Los Medanos College
Campus Key Plan

CCCCD - Los Medanos

Route #1 - Los Medanos Campus

College Complex
Classrooms, Astro Lecture, Social Science and Travel - 7

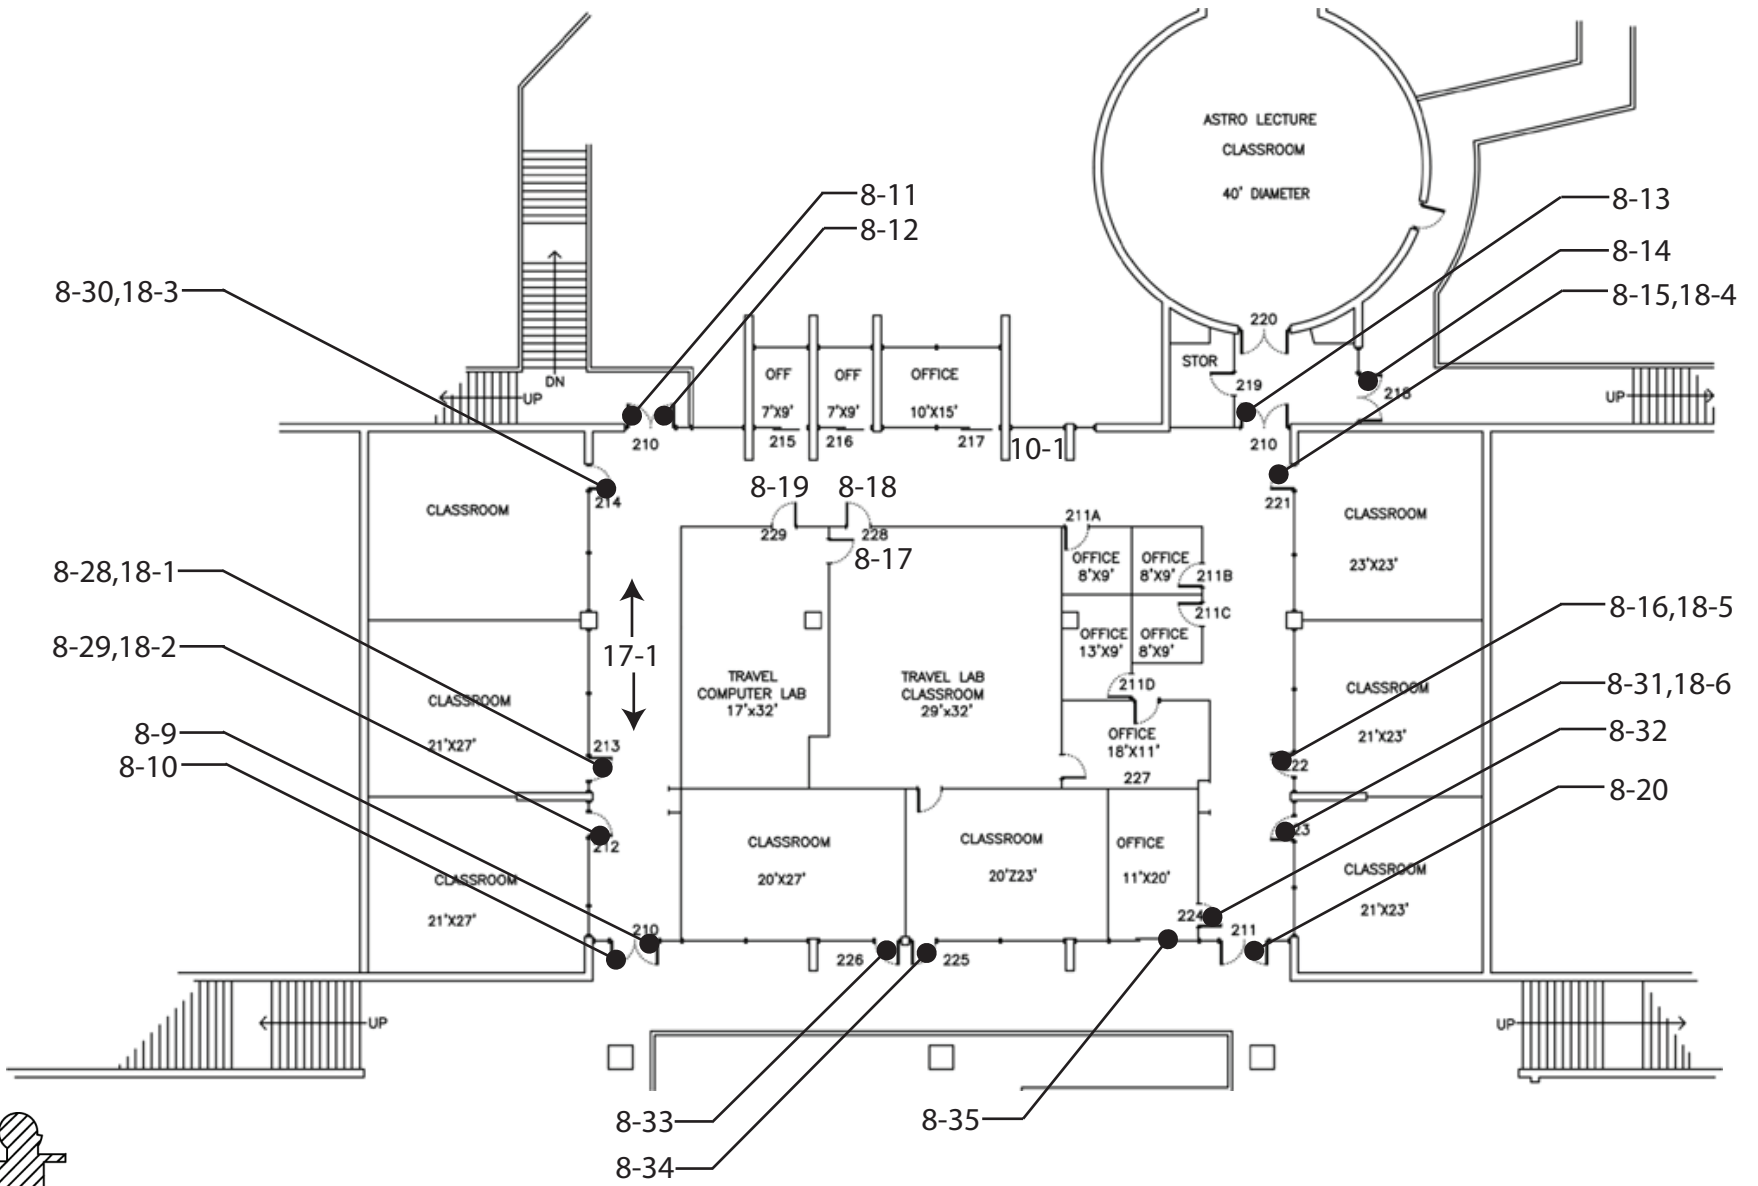
Floor 2		
8 - 9	Door/Gate	Feature Priority: 2
Enlarge door opening		\$1,000
Notes: Width of clear opening is 28" (32" min).		
State: 1133B.2.2, 1133B.2.3		
Federal: 4.13.5		
Action Priority: S		
Adjust door closer		\$50
Notes: Operating effort is 14 lbs (5 lbs max).		
State: 1133B.2.5		
Federal: 4.13.11		
Action Priority: S		
Provide or modify door kickplate		\$250
Notes: Kickplate is 7-1/2" (10" min) high.		
State: 1133B.2.6		
Federal: -		
Action Priority: S		
Install or modify permanent room signs		\$250
Notes: There is an exit sign but Braille is not provided.		
State: -		
Federal: 1117B.5.7, 4.30.6		
Action Priority: S		
8 - 10	Door/Gate	Feature Priority: 3
Enlarge door opening		\$1,000
Notes: Width of clear opening is 28" (32" min).		
State: 1133B.2.2, 1133B.2.3		
Federal: 4.13.5		
Action Priority: S		
Adjust door closer		\$50
Notes: Operating effort is 12 lbs (5 lbs max).		
State: 1133B.2.5		
Federal: 4.13.11		
Action Priority: S

Provide or modify door kickplate		\$250
Notes: Kickplate is 7-1/2" (10" min) high.		
State: 1133B.2.6		
Federal: -		
Action Priority: S

Floor 2		
8 - 11	Door/Gate	Feature Priority: 2
Enlarge door opening		\$1,000
Notes: Width of clear opening is 28" (32" min).		
State: 1133B.2.2, 1133B.2.3		
Federal: 4.13.5		
Action Priority: S		
Adjust door closer		\$50
Notes: Operating effort is 11 lbs (5 lbs max).		
State: 1133B.2.5		
Federal: 4.13.11		
Action Priority: S		
Install or modify permanent room signs		\$250
Notes: There is an exit sign but Braille is not provided.		
State: -		
Federal: 1117B.5.7, 4.30.6		
Action Priority: S		
Provide or modify door kickplate		\$250
Notes: Kickplate is 7-1/2" (10" min) high.		
State: 1133B.2.6		
Federal: -		
Action Priority: S		
8 - 12	Door/Gate	Feature Priority: 3
Enlarge door opening		\$1,000
Notes: Width of clear opening is 28" (32" min).		
State: 1133B.2.2, 1133B.2.3		
Federal: 4.13.5		
Action Priority: S		
Adjust door closer		\$50
Notes: Operating effort is 13 lbs (5 lbs max).		
State: 1133B.2.5		
Federal: 4.13.11		
Action Priority: S

Provide or modify door kickplate		\$250
Notes: Kickplate is 7-1/2" (10" min) high.		
State: 1133B.2.6		
Federal: -		
Action Priority: S

Floor 2	
8 - 13	Door/Gate Feature Priority: 2
Install or modify permanent room signs \$250	
Notes: There is an exit sign but Braille is not provided.	
State: -	
Federal: 1117B.5.7, 4.30.6	
Action Priority: S	
8 - 14	Door/Gate Feature Priority: 2
Install or modify permanent room signs \$250	
Notes: There is an exit sign but Braille is not provided.	
State: -	
Federal: 1117B.5.7, 4.30.6	
Action Priority: S	
8 - 15	Door/Gate Feature Priority: 2
Adjust door closer \$50	
Notes: Operating effort is 12 lbs (5 lbs max).	
State: 1133B.2.5	
Federal: 4.13.11	
Action Priority: S	
Provide or modify door kickplate \$250	
Notes: Kickplate is 4-1/2" (10" min) high.	
State: 1133B.2.6	
Federal: -	
Action Priority: S	
Provide additional strike edge clearance \$1,000	
Notes: Strike-edge clearance on swing-side is 2" (18" min).	
State: 1133B.2.4.3	
Federal: 4.13.6	
Action Priority: S	
Provide additional strike edge clearance \$1,000	
Notes: Strike-edge clearance on push-side is 2" (12" min).

Floor 2	
8 - 16	Door/Gate Feature Priority: 2
Adjust door closer	\$50
Notes: Operating effort is 11 lbs (5 lbs max).	
State: 1133B.2.5	
Federal: 4.13.11	
Action Priority: S	
Provide or modify door kickplate	\$250
Notes: Kickplate is 4-1/2" (10" min) high.	
State: 1133B.2.6	
Federal: -	
Action Priority: S	
8 - 17	Door/Gate Feature Priority: 3
Enlarge door opening	\$1,000
Notes: Height of clear opening is 78-1/2" (80" min).	
State: 1008.11, 1133B.2.2	
Federal: -	
Action Priority: S	
8 - 18	Door/Gate Feature Priority: 2
Enlarge door opening	\$1,000
Notes: Height of clear opening is 78-1/2" (80" min).	
State: 1008.11, 1133B.2.2	
Federal: -	
Action Priority: S	
8 - 19	Door/Gate Feature Priority: 2
Enlarge door opening	\$1,000
Notes: Height of clear opening is 78-1/2" (80" min).	
State: 1008.11, 1133B.2.2	
Federal: -	
Action Priority: S	
8 - 20	Door/Gate Feature Priority: 2
Install or modify permanent room signs	\$250
Notes: There is an exit sign but Braille is not provided.

Floor 2		
8 - 31	Door/Gate	Feature Priority: 2
Adjust door closer		\$50
Notes: Operating effort is 14 lbs (5 lbs max).		
State: 1133B.2.5		
Federal: 4.13.11		
Action Priority: S		
Provide or modify door kickplate		\$250
Notes: Kickplate is 5" (10" min) high.		
State: 1133B.2.6		
Federal: -		
Action Priority: S		
8 - 32	Door/Gate	Feature Priority: 2
Enlarge door opening		\$1,000
Notes: Height of clear opening is 79-1/2" (80" min).		
State: 1008.11, 1133B.2.2		
Federal: -		
Action Priority: S		
Replace or adjust door hardware		\$200
Notes: Doorknob requires grasping and twisting.		
State: 1133B.2.5.2		
Federal: 4.13.9		
Action Priority: S		
8 - 33	Door/Gate	Feature Priority: 2
Provide or modify door kickplate		\$250
Notes: Kickplate is 5" (10" min) high.		
State: 1133B.2.6		
Federal: -		
Action Priority: S		
8 - 34	Door/Gate	Feature Priority: 2
Provide or modify door kickplate		\$250
Notes: Kickplate is 5" (10" min) high.

Floor 2		
8 - 35	Door/Gate	Feature Priority: 3
Provide or modify door kickplate		\$250
Notes: Kickplate is 5" (10" min) high.		
State: 1133B.2.6		
Federal: -		
Action Priority: S		
Replace or modify door threshold		\$200
Notes: Threshold is 1-1/2" (1/2" max) high.		
State: 1133B.2.4.1		
Federal: 4.13.8		
Action Priority: S		
10 - 1	Drinking Fountain	Feature Priority: 3
Replace or reposition drinking fountain		\$2,000
Notes: Height is 17-1/2" (27" min). Depth is 10" (18" min). "Hi-lo" fountain is not provided. Bubbler height is 37" (36" max). Control is located on the top of the bubbler.		
State: 1115B.4.6 #1, 1115B.4.6 #2, 1115B.4.6 #4, 1117B.4.6 #2		
Federal: 4.1.6, 4.15, 4.15.2, 4.15.5		
Action Priority: S		
Adjust water stream		\$100
Notes: Bubbler does not direct water flow.		
State: 1115B.4.6 #4, 1115B.4.6 #5		
Federal: 4.15.3		
Action Priority: S		
17 - 1	Corridor / Aisle	Feature Priority: 1
Reposition controls and outlets		\$200

Notes: 2 fire alarm activation devices are mounted 60" (48" req) above the ground.		
State: CEC 760-16		
Federal: 4.28.2		
Action Priority: <none>		
18 - 1	Room	Feature Priority: 2
Remove overhanging or protruding objects		\$100
Notes: Pencil sharpener protrudes 5-1/2" (4" max) and is 54" (not between 27" to 80") above the finished floor.		
State: 1133B.8.6.1		
Federal: 4.4.1		
Action Priority: S

College Complex
 Language Arts, Classrooms & Reading Room - 9

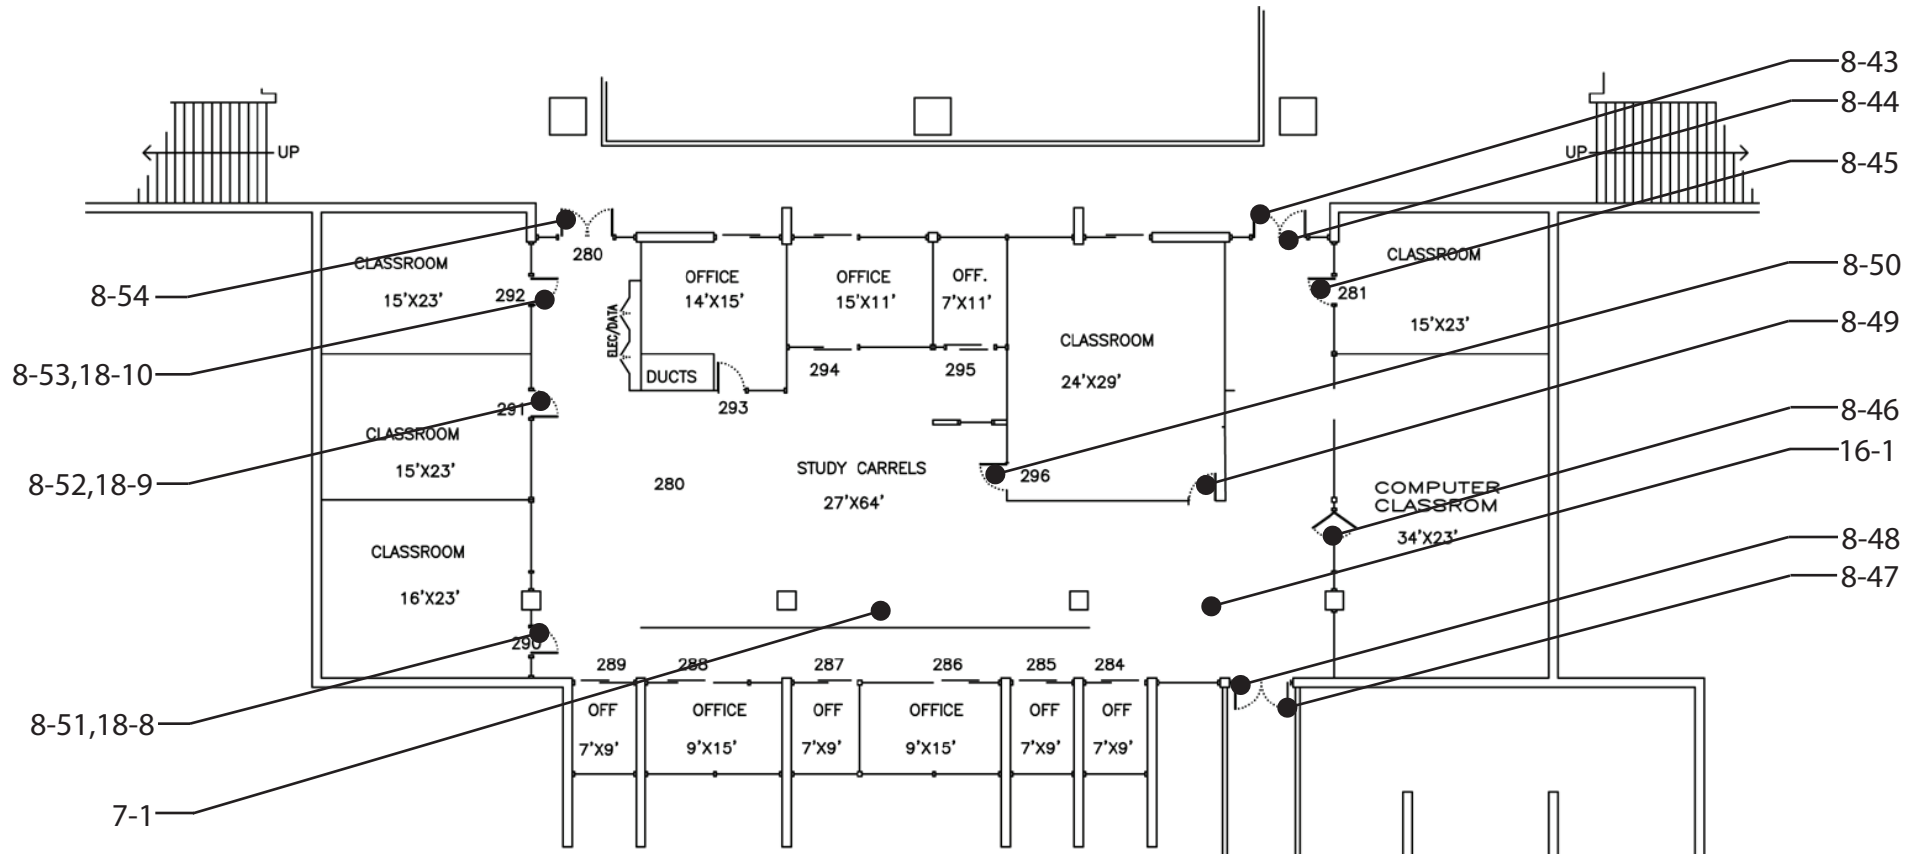
Floor 2		
7 - 1	Hazard	Feature Priority: 1
Remove overhanging or protruding objects		\$100
Notes: Pencil sharpener protrudes 4-1/2" (4" max) and is 38-5/8" (not between 27" to 80") above the finished floor.		
State: 1133B.8.6.1		
Federal: 4.4.1		
Action Priority: M		
8 - 43	Door/Gate	Feature Priority: 1
Adjust door closer		\$50
Notes: Operating effort is 11 lbs (5 lbs max).		
State: 1133B.2.5		
Federal: 4.13.11		
Action Priority: M		
Provide or modify door kickplate		\$250
Notes: Kickplate is 7-1/2" (10" min) high.		
State: 1133B.2.6		
Federal: -		
Action Priority: M		
Install or modify permanent room signs		\$250
Notes: There is an exit sign but Braille is not provided.		
State: -		
Federal: 1117B.5.7, 4.30.6		
Action Priority: M		
8 - 44	Door/Gate	Feature Priority: 1
Adjust door closer		\$50
Notes: Operating effort is 13 lbs (5 lbs max).		
State: 1133B.2.5		
Federal: 4.13.11		
Action Priority: M		
Provide or modify door kickplate		\$250

Floor 2	
8 - 45	Door/Gate Feature Priority: 2
Provide or modify door kickplate \$250	
Notes: Kickplate is 4-1/8" (10" min) high.	
State: 1133B.2.6	
Federal: -	
Action Priority: M	
8 - 46	Door/Gate Feature Priority: 2
Adjust door closer \$50	
Notes: Operating effort is 7 lbs (5 lbs max).	
State: 1133B.2.5	
Federal: 4.13.11	
Action Priority: M	
8 - 47	Door/Gate Feature Priority: 2
Adjust door closer \$50	
Notes: Operating effort is 14 lbs (5 lbs max).	
State: 1133B.2.5	
Federal: 4.13.11	
Action Priority: M	
Provide or modify door kickplate \$250	
Notes: Kickplate is 7" (10" min) high.	
State: 1133B.2.6	
Federal: -	
Action Priority: M	
Install or modify permanent room signs \$250	
Notes: There is an exit sign but Braille is not provided.	
State: -	
Federal: 1117B.5.7, 4.30.6	
Action Priority: M

Floor 2		
8 - 52	Door/Gate	Feature Priority: 2
Adjust door closer		\$50
Notes: Operating effort is 10 lbs (5 lbs max).		
State: 1133B.2.5		
Federal: 4.13.11		
Action Priority: M		
Provide or modify door kickplate		\$250
Notes: Kickplate is 4-1/2" (10" min) high.		
State: 1133B.2.6		
Federal: -		
Action Priority: M		
8 - 53	Door/Gate	Feature Priority: 2
Adjust door closer		\$50
Notes: Operating effort is 10 lbs (5 lbs max).		
State: 1133B.2.5		
Federal: 4.13.11		
Action Priority: M		
Provide or modify door kickplate		\$250
Notes: Kickplate is 4-1/2" (10" min) high.		
State: 1133B.2.6		
Federal: -		
Action Priority: M		
8 - 54	Door/Gate	Feature Priority: 2
Install or modify permanent room signs		\$250
Notes: There is an exit sign but Braille is not provided.		
State: -		
Federal: 1117B.5.7, 4.30.6		
Action Priority: M		
16 - 1	Transaction Counter	Feature Priority: 3
Provide an accessible counter		\$1,000
Notes: Counter is 40" (28" to 34" max) above the finished floor.

College Complex
Math Labs - 10

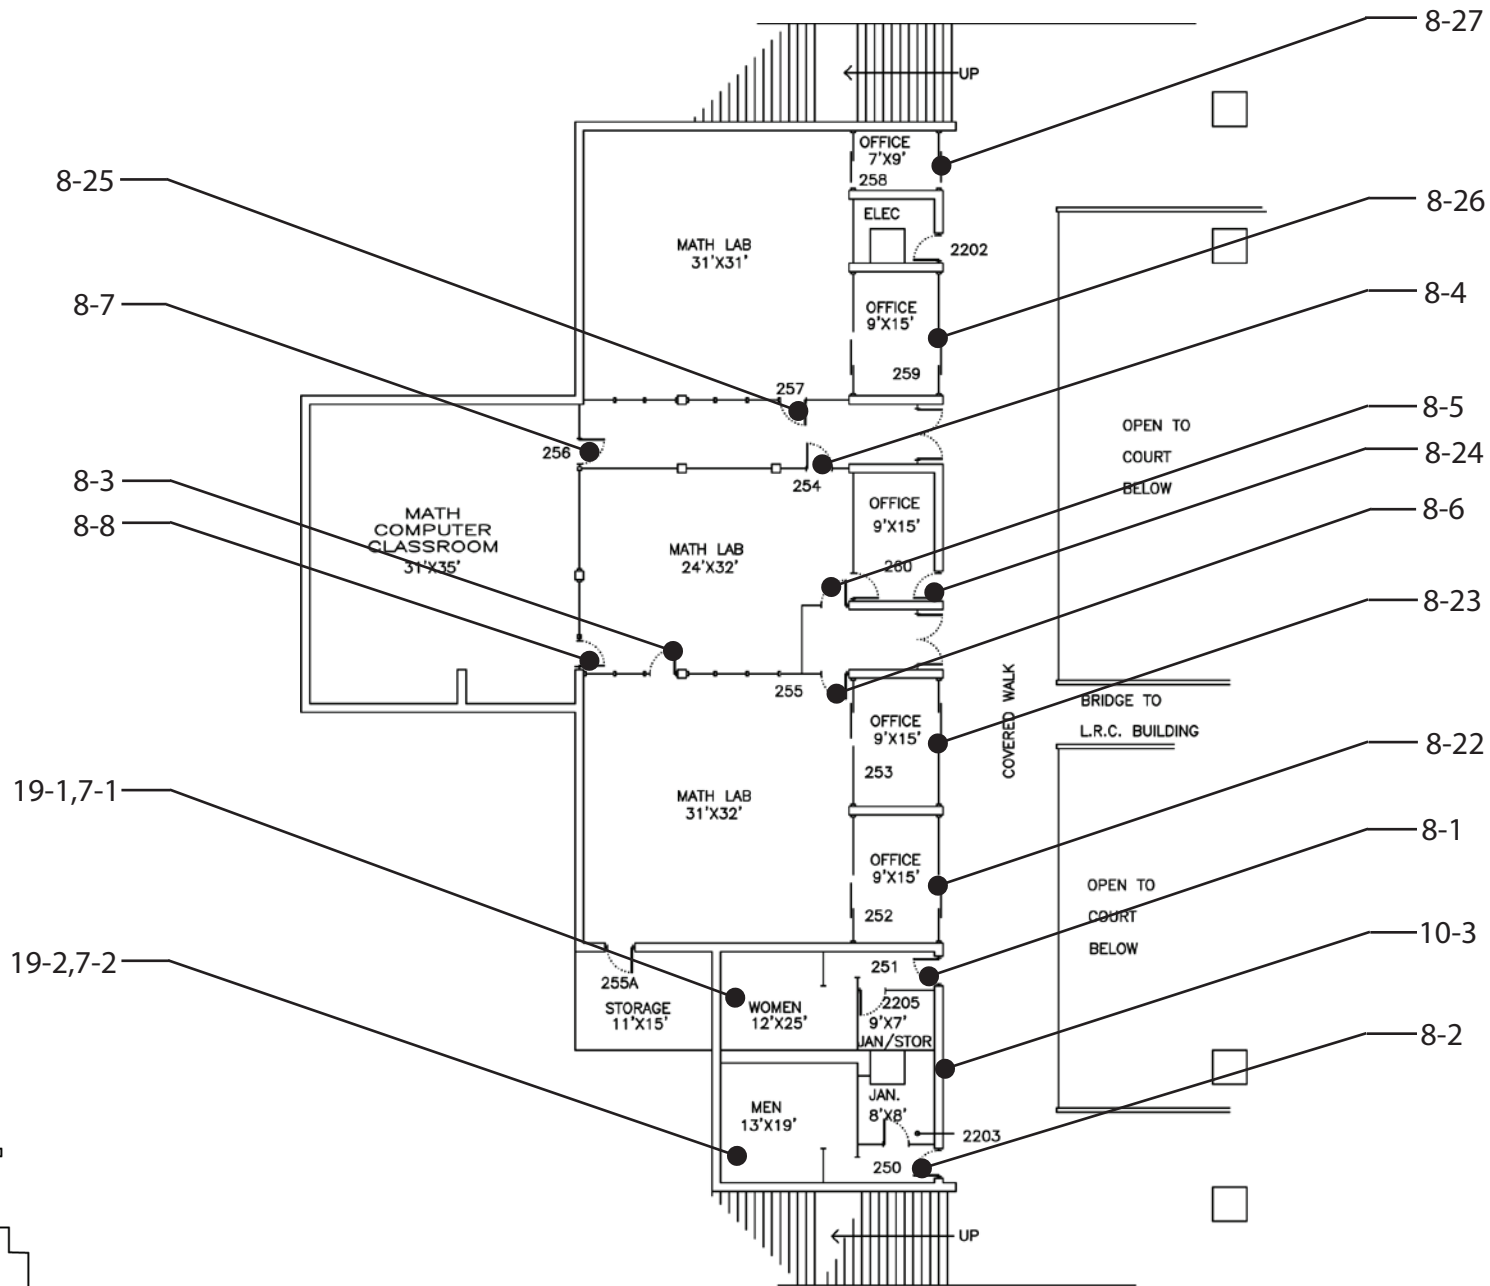
Floor 2	
8 - 1	Door/Gate
Feature Priority: 2	
Replace or modify door threshold	\$200
Notes: Threshold is 1-1/4" (1/2" max) high.	
State: 1133B.2.4.1	
Federal: 4.13.8	
Action Priority: M	
Adjust door closer	\$50
Notes: Operating effort is 29 lbs (5 lbs max).	
State: 1133B.2.5	
Federal: 4.13.11	
Action Priority: M	
Provide or modify door kickplate	\$250
Notes: Doorstop is mounted on kickplate.	
State: 1133B.2.6	
Federal: -	
Action Priority: M	
Increase or provide maneuvering or clear floor area	\$1,000
Notes: Level space on swing-side is 49" (60" min).	
State: 1133B.2.4.2	
Federal: 4.13.6	
Action Priority: M	
Provide additional strike edge clearance	\$1,000
Notes: Strike-edge clearance on swing-side is 6-1/2" (18" min).	
State: 1133B.2.4.3	
Federal: 4.13.6	
Action Priority: M

Floor 2	
8 - 2	Door/Gate Feature Priority: 2
Replace or modify door threshold	\$200
Notes: Threshold is 1-1/4" (1/2" max) high.	
State: 1133B.2.4.1	
Federal: 4.13.8	
Action Priority: M	
Adjust door closer	\$50
Notes: Operating effort is 9 lbs (5 lbs max).	
State: 1133B.2.5	
Federal: 4.13.11	
Action Priority: M	
Increase or provide maneuvering or clear floor area	\$1,000
Notes: Level space on swing-side is 48" (60" min).	
State: 1133B.2.4.2	
Federal: 4.13.6	
Action Priority: M	
Provide additional strike edge clearance	\$1,000
Notes: Strike-edge clearance on swing-side is 9-1/4" (18" min).	
State: 1133B.2.4.3	
Federal: 4.13.6	
Action Priority: M	
8 - 3	Door/Gate Feature Priority: 2
Adjust door closer	\$50
Notes: Operating effort is 8 lbs (5 lbs max).	
State: 1133B.2.5	
Federal: 4.13.11	
Action Priority: M	
Provide additional strike edge clearance	\$1,000
Notes: Strike-edge clearance on swing-side is 11-1/2" (18" min).

Floor 2		
8 - 4	Door/Gate	Feature Priority: 2
Enlarge door opening		\$1,000
Notes: Height of clear opening is 75-1/2" (80" min).		
State: 1008.11, 1133B.2.2		
Federal: -		
Action Priority: L		
Replace or adjust door hardware		\$200
Notes: Doorknob requires grasping and twisting.		
State: 1133B.2.5.2		
Federal: 4.13.9		
Action Priority: M		
Provide or modify door kickplate		\$250
Notes: Doorstop is mounted on kickplate.		
State: 1133B.2.6		
Federal: -		
Action Priority: M		
8 - 5	Door/Gate	Feature Priority: 2
Adjust door closer		\$50
Notes: Operating effort is 7 lbs (5 lbs max).		
State: 1133B.2.5		
Federal: 4.13.11		
Action Priority: M		
Provide or modify door kickplate		\$250
Notes: Doorstop is mounted on kickplate.		
State: 1133B.2.6		
Federal: -		
Action Priority: M		
Replace or adjust door hardware		\$200
Notes: Doorknob requires grasping and twisting.		
State: 1133B.2.5.2		
Federal: 4.13.9		
Action Priority: M		
Enlarge door opening		\$1,000

Floor 2		
8 - 6	Door/Gate	Feature Priority: 2
Adjust door closer		\$50
Notes: Operating effort is 11 lbs (5 lbs max).		
State: 1133B.2.5		
Federal: 4.13.11		
Action Priority: M		
Replace or adjust door hardware		\$200
Notes: Doorknob requires grasping and twisting.		
State: 1133B.2.5.2		
Federal: 4.13.9		
Action Priority: M		
Enlarge door opening		\$1,000
Notes: Height of clear opening is 79" (80" min).		
State: 1008.11, 1133B.2.2		
Federal: -		
Action Priority: L		
Provide or modify door kickplate		\$250
Notes: Doorstop is mounted on kickplate.		
State: 1133B.2.6		
Federal: -		
Action Priority: M		
8 - 7	Door/Gate	Feature Priority: 2
Adjust door closer		\$50
Notes: Operating effort is 7 lbs (5 lbs max).		
State: 1133B.2.5		
Federal: 4.13.11		
Action Priority: M		
Provide additional strike edge clearance		\$1,000
Notes: Strike-edge clearance on swing-side is 1" (18" min).		
State: 1133B.2.4.3		
Federal: 4.13.6		
Action Priority: L

Floor 2	
8 - 8	Door/Gate Feature Priority: 2
Adjust door closer	\$50
Notes: Operating effort is 8 lbs (5 lbs max).	
State: 1133B.2.5	
Federal: 4.13.11	
Action Priority: M	
8 - 22	Door/Gate Feature Priority: 2
Replace or modify door threshold	\$200
Notes: Threshold is 1-1/2" (1/2" max) high.	
State: 1133B.2.4.1	
Federal: 4.13.8	
Action Priority: M	
8 - 23	Door/Gate Feature Priority: 2
Replace or modify door threshold	\$200
Notes: Threshold is 1-1/2" (1/2" max) high.	
State: 1133B.2.4.1	
Federal: 4.13.8	
Action Priority: M	
Install or modify permanent room signs	\$250
Notes: There is an exit sign but Braille is not provided.	
State: -	
Federal: 1117B.5.7, 4.30.6	
Action Priority: M	
8 - 24	Door/Gate Feature Priority: 2
Increase or provide maneuvering or clear floor area	\$1,000
Notes: Slope on the push-side is 5.8% (2% max).	
State: 1133B.2.4.2	
Federal: 4.13.6	
Action Priority: L

Floor 2	
10 - 3	Drinking Fountain Feature Priority: 3
Provide wing walls or textured floor surface	\$300
Notes: Drinking fountain is not located in an alcove.	
State: 1115B.4.6 #3	
Federal: 4.15.5	
Action Priority: M	
Replace or reposition drinking fountain	\$2,000
Notes: Height is 22" (27" min). Depth is 9" (18" min). "Hi-lo" fountain is not provided. Bubbler height is 43" (36" max). Control is located on top of bubbler.	
State: 1115B.4.6 #1, 1115B.4.6 #2, 1115B.4.6 #4, 1117B.4.6 #2	
Federal: 4.1.6, 4.15, 4.15.2, 4.15.5	
Action Priority: M	
Replace or adjust water controls	\$250
Notes: Operating effort is 7 lbs (5 lbs max).	
State: 1115B.4.6 #4	
Federal: 4.15.4	
Action Priority: M

Floor 2	
19 - 1	Multiple User Restroom
Feature Priority: 2	
Install sign	\$200
Notes: California required signage is not provided on the door.	
State: 1115B.6	
Federal: -	
Action Priority: M	
Install sign	\$200
Notes: Federal required signage is not provided on the latch side of the door. International Symbol of Accessibility is not provided.	
State: 1115B.6, 1117B.5.8.1.2	
Federal: 4.30.4	
Action Priority: M	
Increase or provide maneuvering or clear floor area	\$1,000
Notes: Clear space of 36" (44" min) is provided throughout the restroom.	
State: 1115B.3.1 #4.5	
Federal: 4.17.1	
Action Priority: S	
Replace or reposition dispensers or mirrors	\$50
Notes: Mirror is mounted so bottom of reflecting surface is 43-1/2" (40" max) above the finished floor.	
State: 1115B.8.1	
Federal: 4.19.6	
Action Priority: M	
Replace or reposition dispensers or mirrors	\$50
Notes: Towel dispenser is 43" (40" max) above the finished floor.

State: 1115B.8.3	
Federal: 4.23.7	
Action Priority: M	
Replace or adjust water controls	\$250
Notes: Operating effort is 8 lbs (5 lbs max).	
State: 1115B.8.3	
Federal: 4.19.5, 4.27.4	
Action Priority: S	
Modify stall partitions and doors	\$1,000
Notes: Door width for end-entry stall is 30-1/2" (32" min).	
State: 1115B.3.1 #4.4	
Federal: -	
Action Priority: S

Floor 2	
19 - 1	Multiple User Restroom Feature Priority: 2
Replace or reposition fixtures	\$1,000
Notes: Space from the wall to the centerline of the toilet is 19" (18" req).	
State: 1115B.7.1.3	
Federal: 4.17.3	
Action Priority: M	
Modify stall partitions and doors	\$1,000
Notes: Space from the edge of the toilet to the wall is 12" (32" min).	
State: 1115B.4.1 #1	
Federal: 4.17.3	
Action Priority: S	
Modify stall partitions and doors	\$1,000
Notes: Space in front of the toilet is 31" (48" min).	
State: 1115B.3.1 #4.1	
Federal: 4.17.3	
Action Priority: S	
Modify stall partitions and doors	\$1,000
Notes: Stall width is 37" (60" min).	
State: -	
Federal: 4.17.3	
Action Priority: S	
Replace or reposition dispensers or mirrors	\$50
Notes: Seat cover dispenser is 48" (40" min) above the finished floor.	
State: 1115B.8.3	
Federal: 4.23.7	
Action Priority: M	
Replace or modify grab bars	\$500
Notes: Rear grab bar is not provided. Side grab bar is positioned so the front end is 49" (54" min) from the back wall. Space between the wall and the grab bar is 2-1/4" (1-1/2").

State: 1115B.4.1 #3.1, 1115B.4.1 #3.2, 1115B.7.1	
Federal: 4.17.6	
Action Priority: M	
Provide an additional front transfer stall	\$1,000
Notes: Front transfer stall is not provided.	
State: 1115B.3.1 #5, 1115B.4.1 #3, 1115B.5	
Federal: 4.17.3	
Action Priority: S
